Please find attached the January 2017 amendments to C/AS7 Acceptable Solution for Buildings Used for Vehicle Storage and Parking (Risk Group VP), published by the Ministry of Business, Innovation and Employment.

<b>Section</b>	<b>Previous version</b>	<b>January 2017 Amendment 4</b>
<b>C/AS7 Acceptable Solution for Buildings Used for Vehicle Storage and Parking (Risk Group VP)</b>		
Title pages	Remove document history/status	Replace with new title page and document history/status
C/AS7 Part 2	Remove page 15/16	Replace with new page 15/16
C/AS7 Parts 4 and 5	Remove page 19/20	Replace with new page 19/20

**C/AS7**

**Acceptable Solution for Buildings  
Used for Vehicle Storage and Parking  
(Risk Group VP)**

**Figure 4.18 Car parking**  
Paragraphs 4.1.1 and 4.1.2

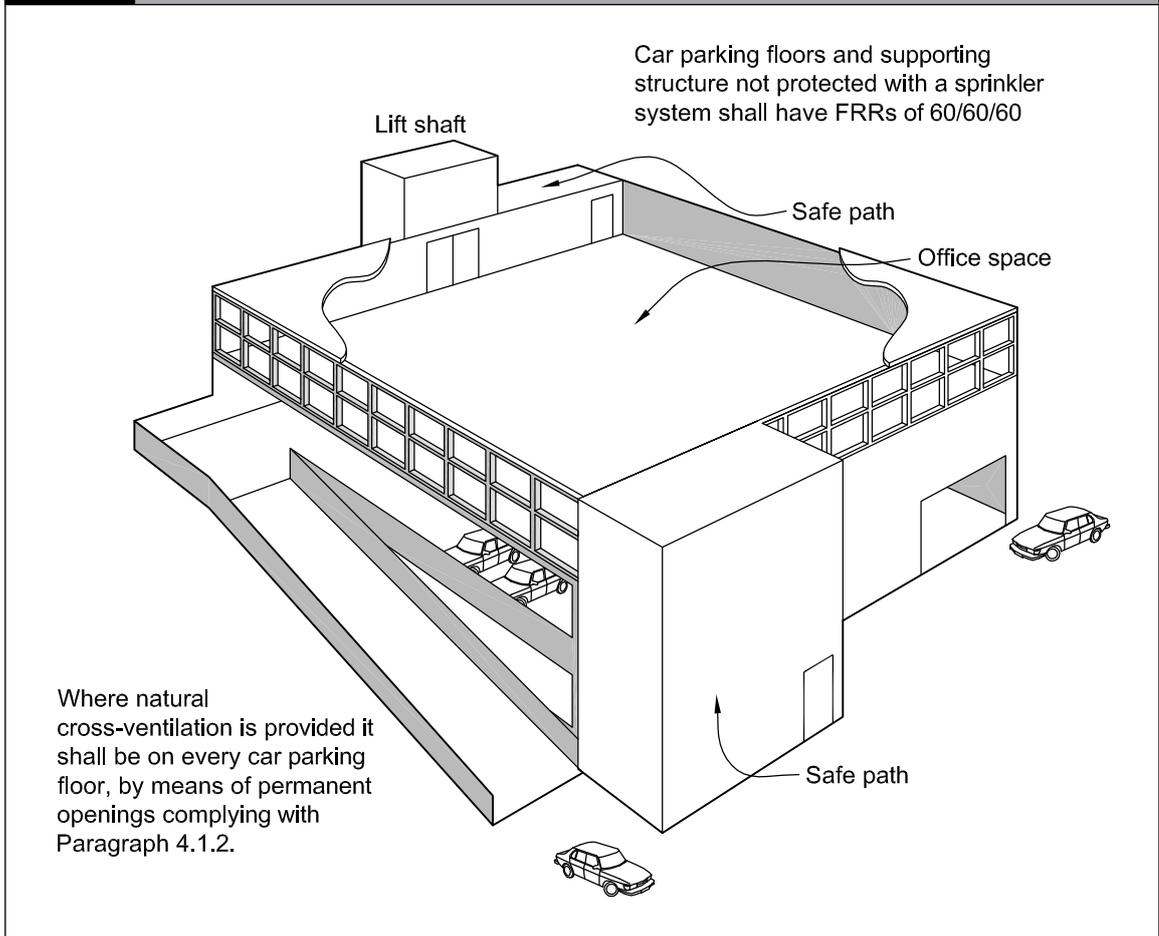
**4.1.2.** Cross ventilation requirements (see Figure 4.18) for every car parking floor shall be as follows:

- a) Where there is parking for more than 10 cars and the *building* is not sprinklered, cross ventilation in accordance with b) is required, and
- b) Effective cross ventilation in a car parking *firecell* is achieved by providing perimeter walls on each floor with permanent openings to the outside environment. The size of those openings shall either be:
  - i) no less than 50% of the wall area in each of any two opposing walls, or
  - ii) no less than 50% of the total perimeter wall area, with those openings distributed uniformly along at least half the total perimeter wall length.

**4.1.3** Where cross ventilation or sprinklers are provided the limitations on *intermediate floor* area do not apply.
